CARROLL COUNTY PILE REPAIRS
2026

ADDENDUM NO. 2

July 27, 2026

REPLACE CALLOUT ON PLAN SHEETS 4 AND 46 OF 53 WITH:

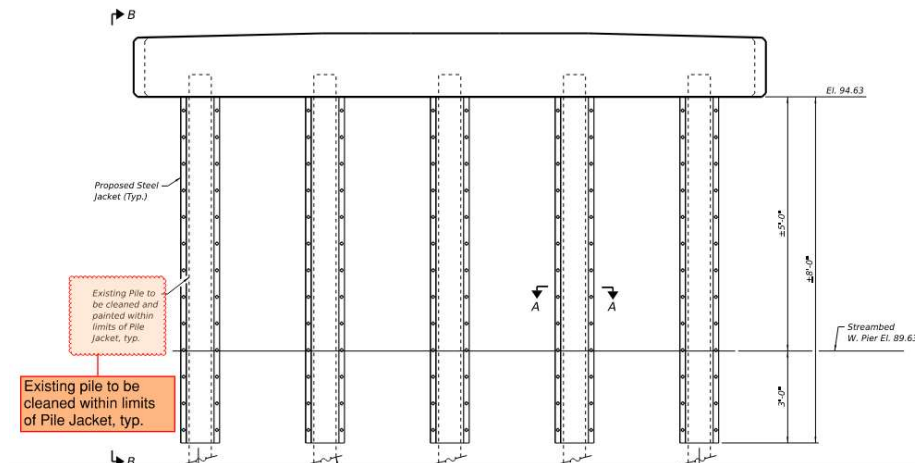
1) EXISTING PILE TO BE CLEANED WITHIN LIMITS OF PILE JACKET, TYP.
